Wembdon Parish Council

Cokerhurst Farm planning application 51/19/00003 Addendum to existing WPC objection

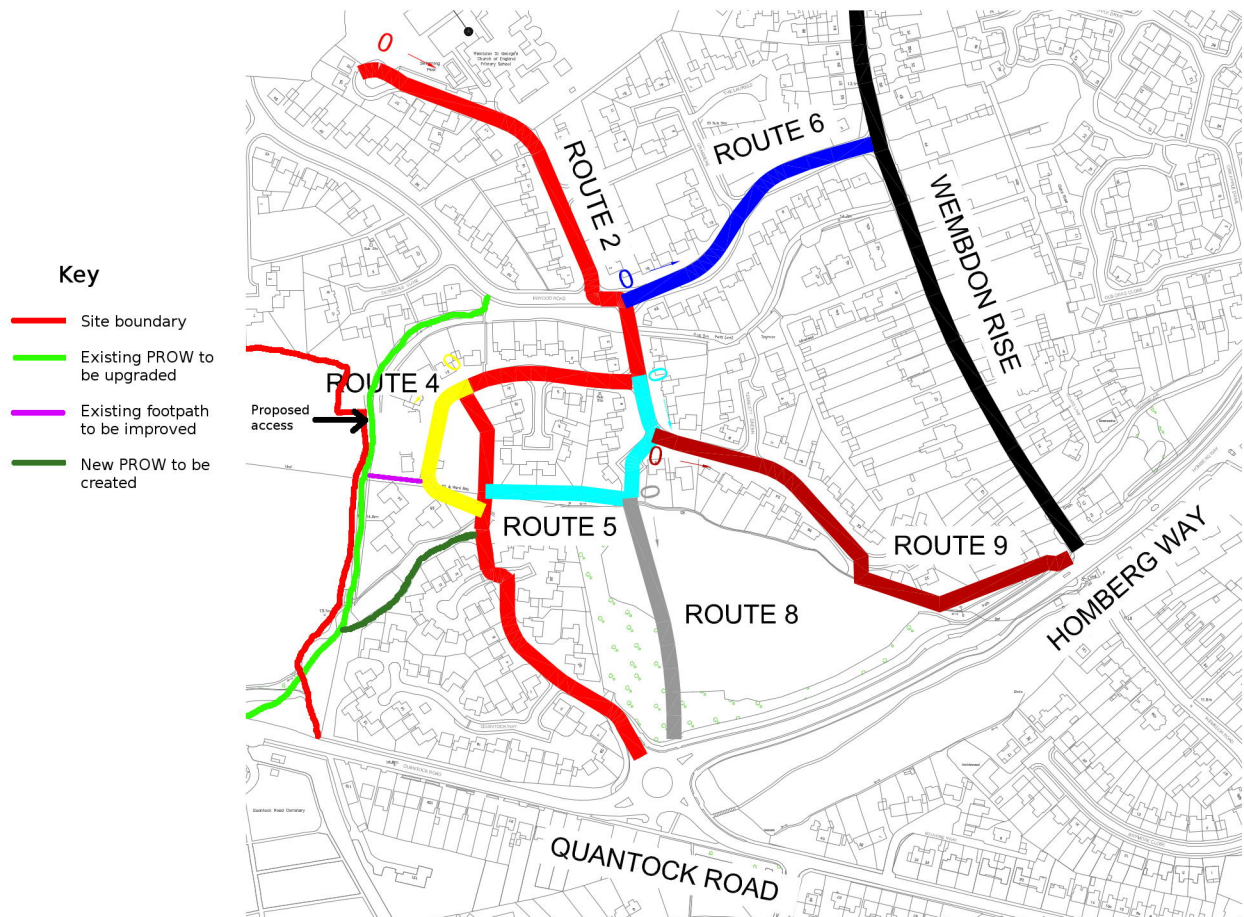
Somerset County Council (SCC) have prepared a plan showing proposed improvements to existing cycle routes as well as proposed new routes. This plan is referenced in para 7.12 of Appendix 10.2

of the Environmental Statement in the current application, with the plan included as Appendix F of that statement, and a section of it reproduced below (with additional annotations).

Although para 7.12 refers to contributing to those enhancements through a s106 agreement, the SCC routes are not adjacent to the site, and this planning application contains no proposal to integrate with any of those routes on the Eastern side, which is the direction most of the residents would be likely to use.

In order to integrate with the existing network, a new footway / cycleway should also be created, past the rear of the houses in Quantock Meadow (see plan). This would have the added advantage of providing alternative safe routes from the proposed development to Whitegates Roundabout and the Wembdon Rise / Homberg Way junction. There is also a short existing footpath (indicated on the plan) which would benefit from improvement. Both of these improvements should be provided by a s106 agreement.
